REPORT HAZOP

East Coast Grid Expansion MW880 Milne CS HAZOP Typical for MW880 and MW433 New (Stage 1 and 2) Installations on MOOMBA WILTON PIPELINE

Project No		21100			
Document No		21100-RP-R-0002			
Rev	Date	Status	Originated/ Custodian	Checked	Approved
1	13/05/21	Issued for Use			
			R. Fagarasan Principal Mechanical Engineer	C. Button Team Lead-Process & Pipeline Engineering	P. Orangi Team Lead Bid Support

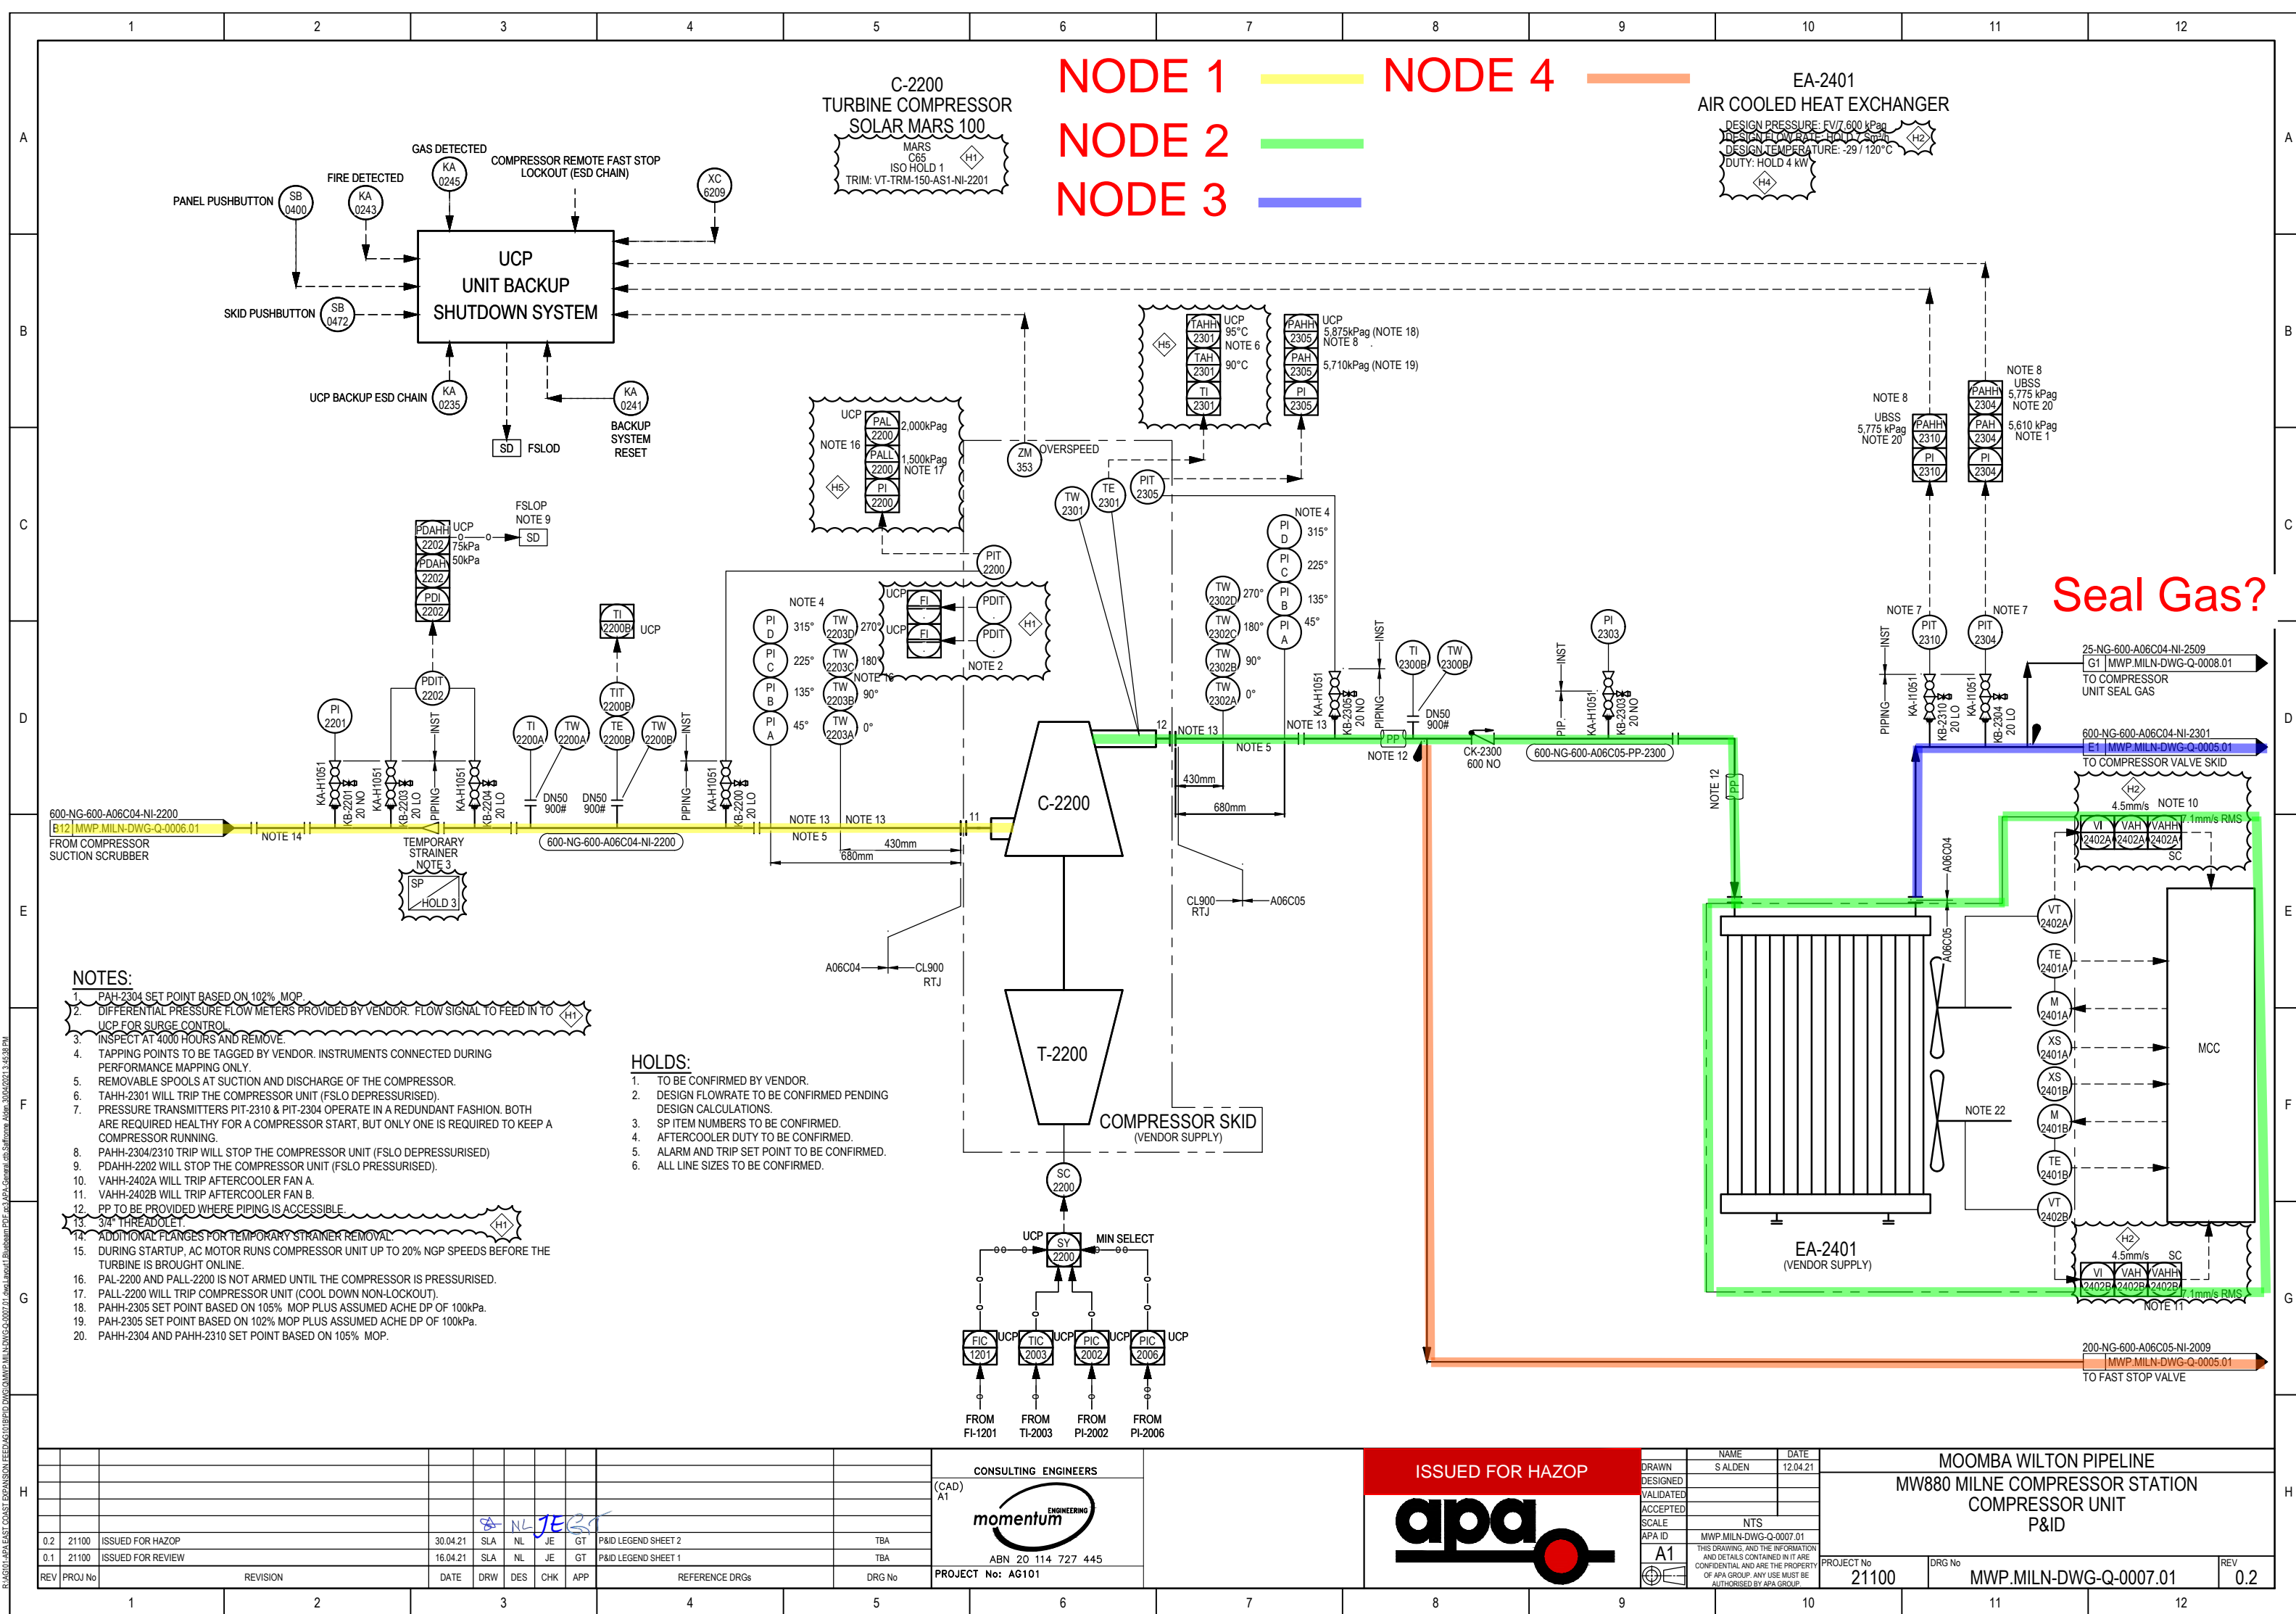
1	High Temperature	N1-8-2	Hot fast stop recycle line fail open	AS ABOVE	NONE	Implement compressor unit trip on high suction temperature (e.g. TIT-2200B) set a piping design limit	JE	10	FEED			
1	General	N1-19-1	incorrect symbols on PID regarding solenoid valve or limit switches on actuated valves (solenoids missing or shown in incorrect position)	confusion in operation	NONE	show the correct symbols and functionality for the actuated valves in accordance with APA standard 530-SP-P-0037	JE / MP	11	FEED			
1	General	N1-19-2	incorrect symbols on PID-MW43-0120 regarding the Valve DIB-0001 regarding body bleed	Incorrect depiction of the valve confusion in operation	NONE	show the correct symbols and functionality for DIB-0001	JE	12	FEED			
1	General	N1-19-3	Transitions for underground to aboveground missing on PID-MW43-0120	Incorrect depiction of equipment confusion in operation	NONE	show the correct Transitions for underground to aboveground on PID-MW43-0120	JE / CD / SH	13	FEED

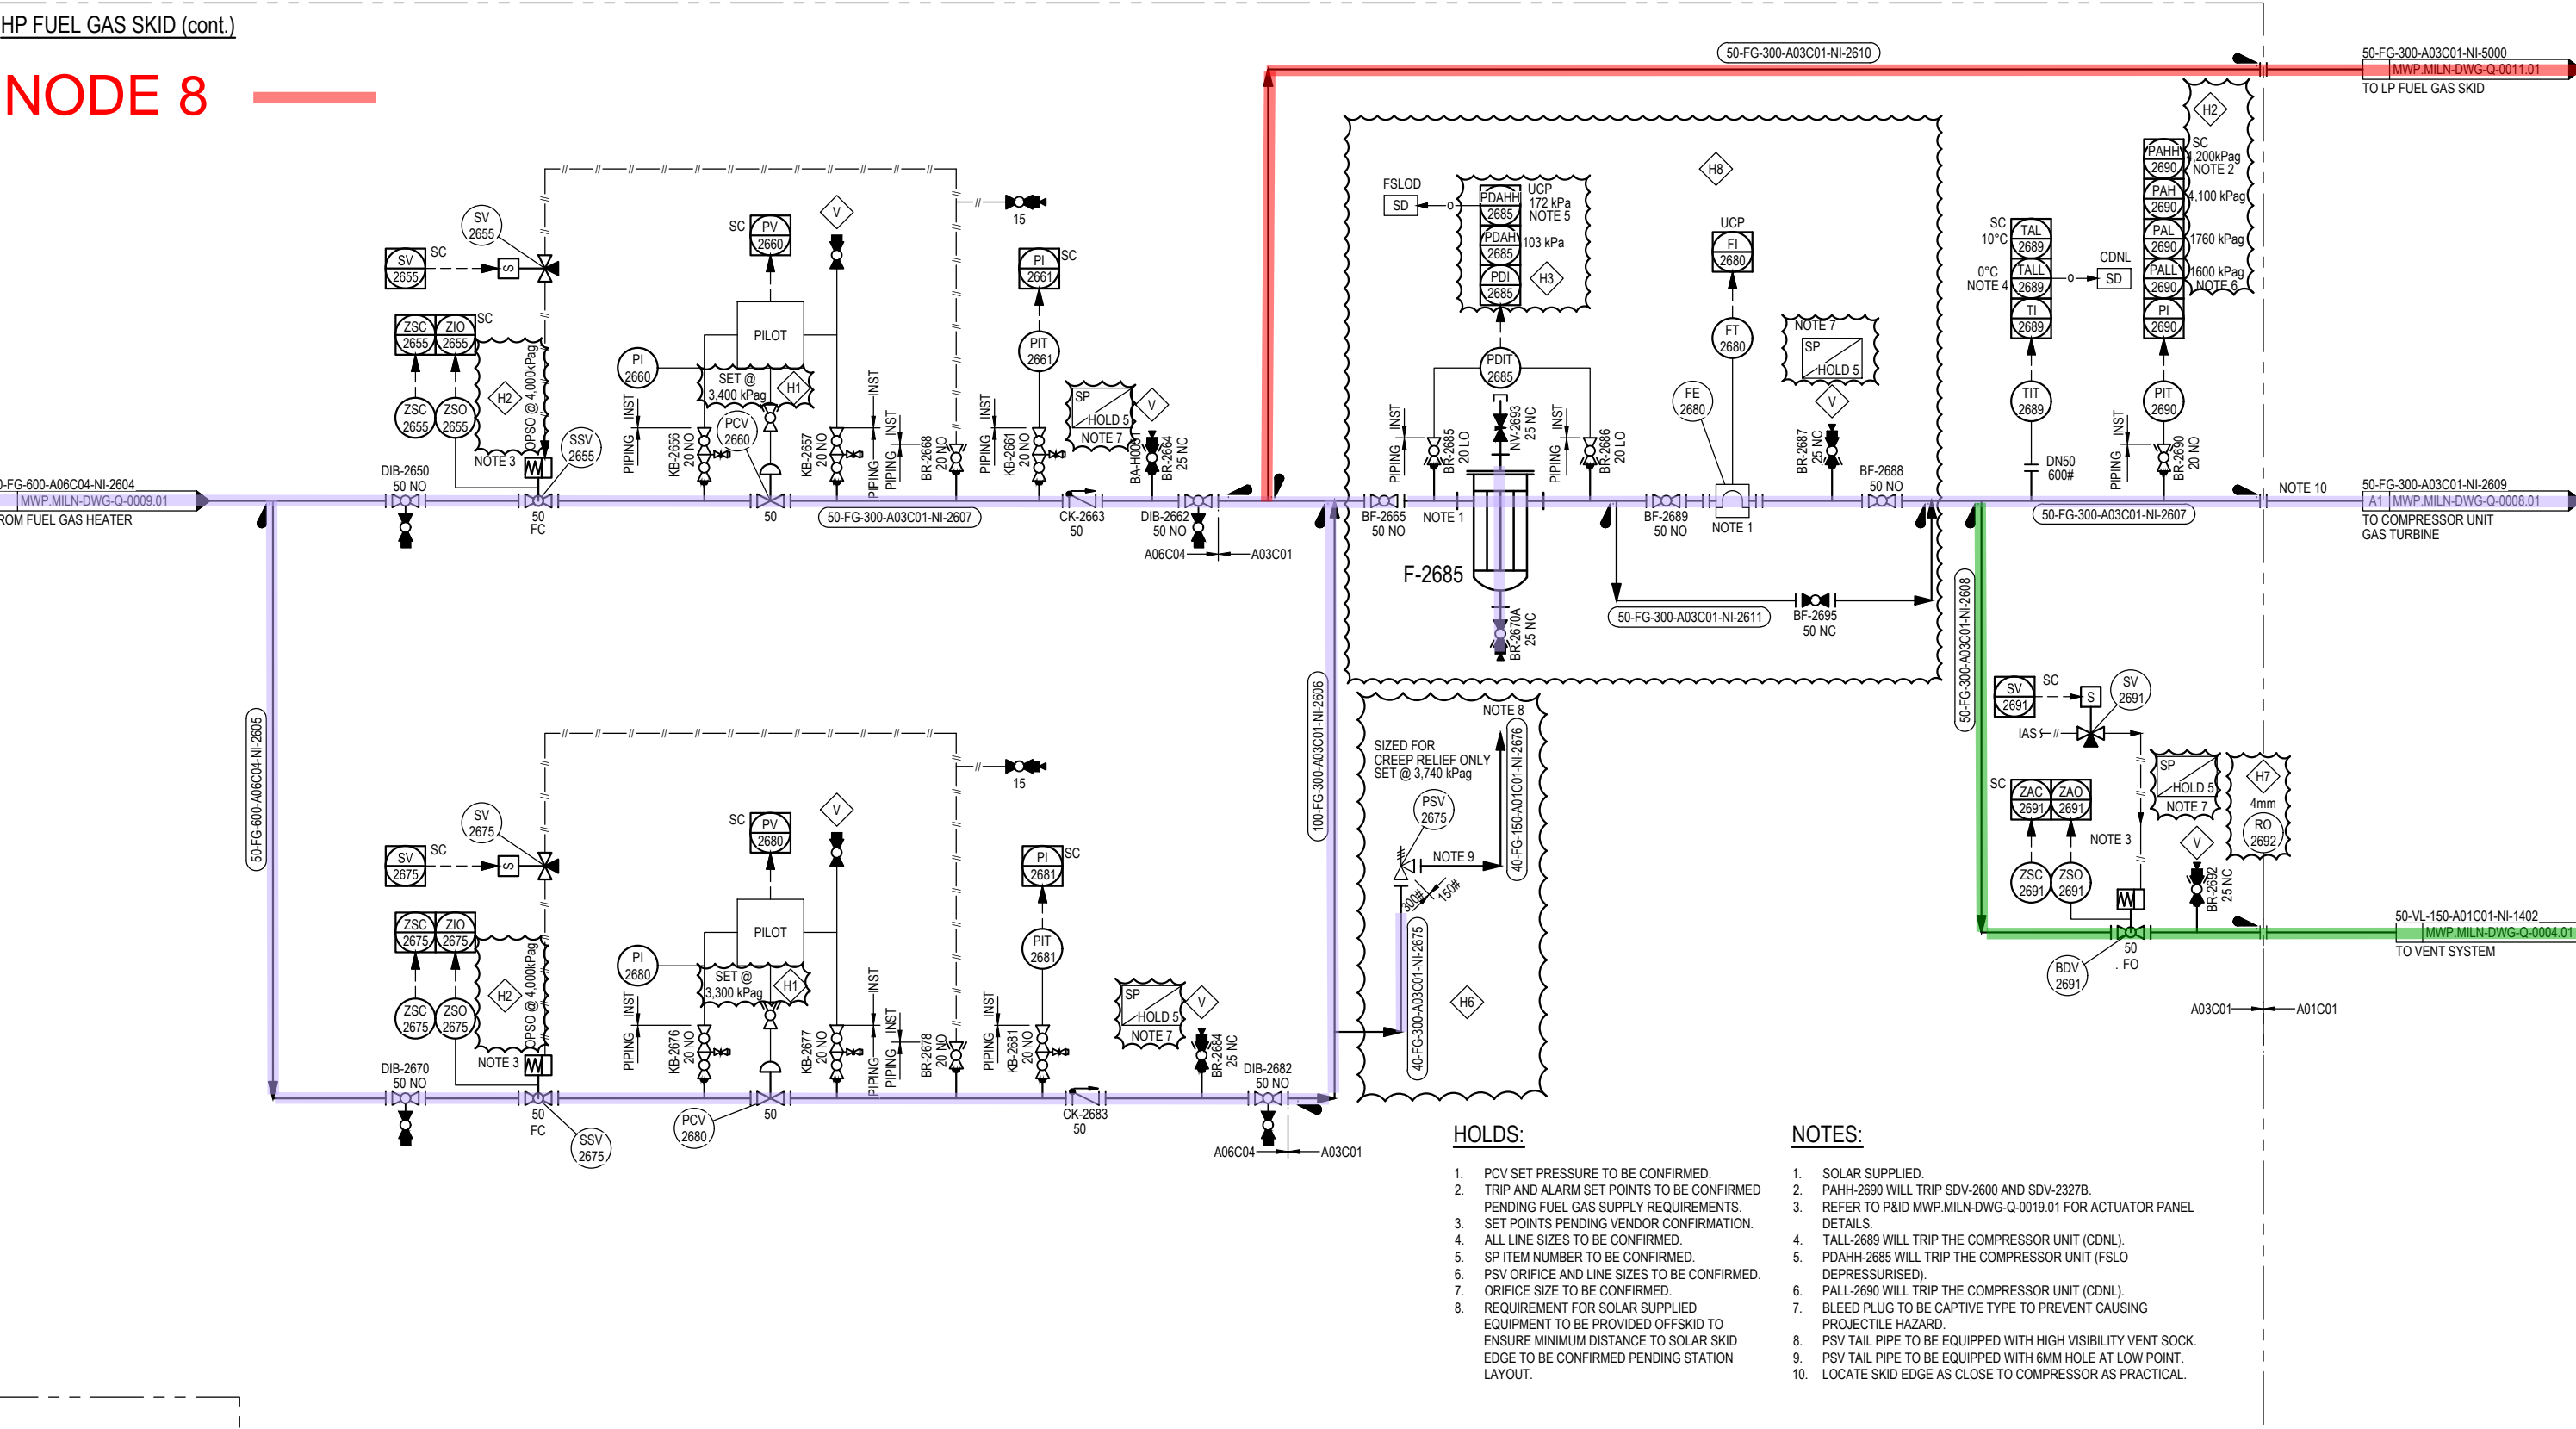
7	General	N7-19-4	Filter vessel F-2685 is not protected by fire pressure relief as required by the pressure vessel code	Code non compliance	NONE	Establish whether F-2685 is a pressure vessel or not and add fire case PSV if it is a pressure vessel	JE	75	FEED			
7	General	N7-19-5	Basket strainer filter in the Solar supply upstream SDV-2327B is not shown on the PID	Incorrect depiction of equipment	NONE	show the basket strainer filter upstream of SDV-2327B on PID-Q-0008 and clearly mark it as part of Solar supply	JE	76	FEED			
7	General	N7-19-6	F-2610 / F-2630 currently shown as dust filters on the PID	Incorrect depiction of equipment	NONE	F-2610 / F-2630 are to be specified and shown as the filter coalescing type filters on the PIDs	JE	77	FEED			
7	General	N7-19-7	Fuel gas PIDs currently depict a specific PCV / slam shut configuration	The final selected elements may not be reflected on the PIDs	NONE	Once the final elements (PCV / SS) is selected by the vendor, depict the correct hook up configuration on the PID (e.g. pilot, sensing lines)	JE	78	DD

7	General	N7-19-8	thermowell, temperature element, size and rating not shown on the PID on TIT-2689	incorrect depiction of equipment	NONE	show the thermowell, temperature element, size and rating on the PID on TIT-2689 as well as the correct installation detail in 50 NB piping	JE	79	FEED			
7	General	N7-19-9	Slam shut SSV-2655 or SSV-2675 trips leads to call out on site	potentially unnecessary call out	NONE	Consider whether a remote or automatic reset of slam shut by IOC should be implemented	CB	80	FEED/DD			
7	General	N7-19-10	unnecessary functionality by having open and close signals to SSVs	potential unnecessary complexity	NONE	Consider whether a remote open or close operation of slam shut is required by IOC	CB	81	FEED/DD			
7	General	N7-19-11	different configuration of pneumatic lines going to the actuators of SSV-2655 / SSV-2675 is incorrect	incorrect depiction of equipment which is not rated for 4,000 kPa	NONE	Show the correct lines going into the SSV actuators SSV-2655 / SSV-2675 and show the correct equipment and functionality desired for the two slam shut valves	MP / JE	82	FEED

Action:
Show the thermowell, temperature element, size and rating on the PID on TIT-2689 as well as the correct installation detail in 50 NB piping.
